**ADDENDUM #2**

**MSAD #72  
PRE-K-8 SCHOOL AT MOLLY OCKETT  
FRYEBURG, MAINE**

**APRIL 29, 2015**

FIGURE  
**CSK-7**

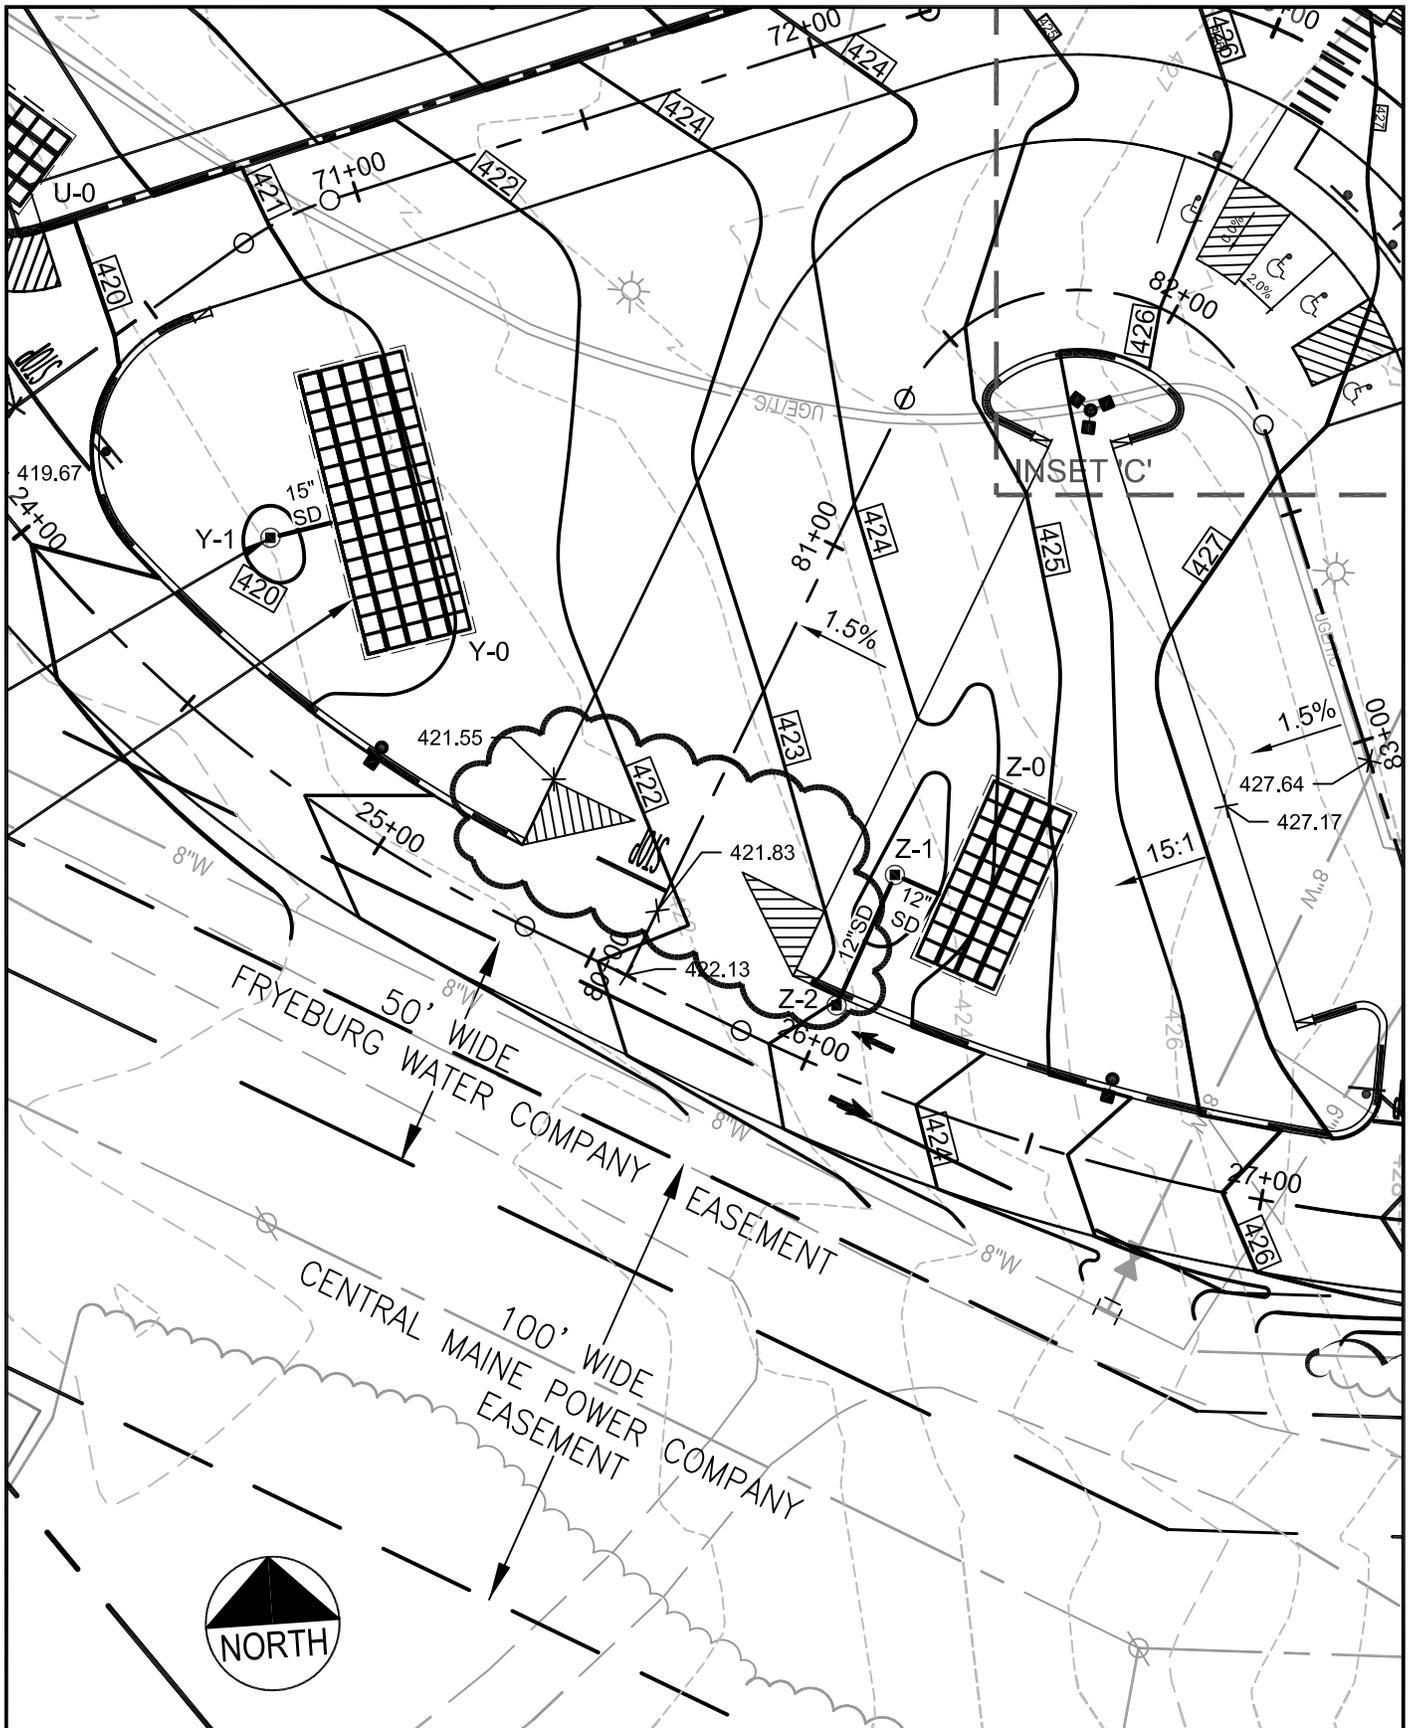
A. The grading plan has been revised to provide grading information in the vicinity of the relocated gazebo and structural fill pad. This revision to Sheet C-3.2 is shown on CSK-7 that is appended to this addendum.

**EXCERPT OF SHEET C-3.2  
REVISED GRADING AT STRUCTURAL FILL  
GRAVEL PAD FOR GAZEBO**
